## 92201802-FA - Capio Suture Management Technique Advisory Field Action

12-Feb-2018

# Important Medical Device Information

Capio™ Suture Capturing Devices (SLIM, Standard, Open Access, RP)

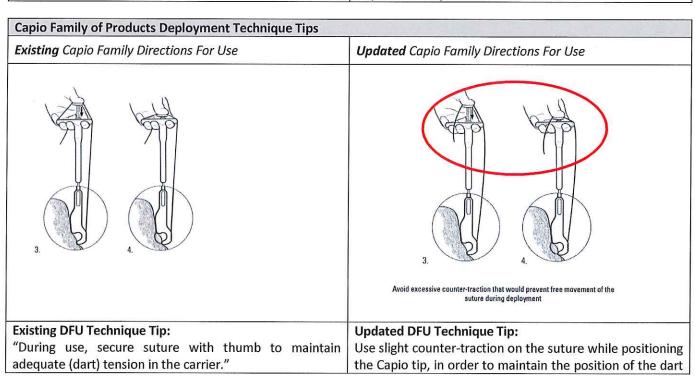
If the Capio suture or pelvic floor kit mesh assembly is placed under excessive counter-traction during deployment, it can result in an interaction between the suture and the Capio carrier that could potentially damage the suture and may cause the dart to detach. The testing confirmed that higher amounts of counter-traction (tension) placed on the Capio

suture or pelvic floor kit mesh assembly during deployment contributes to an increased likelihood of damage to the Capio suture and potential Capio dart detachment.
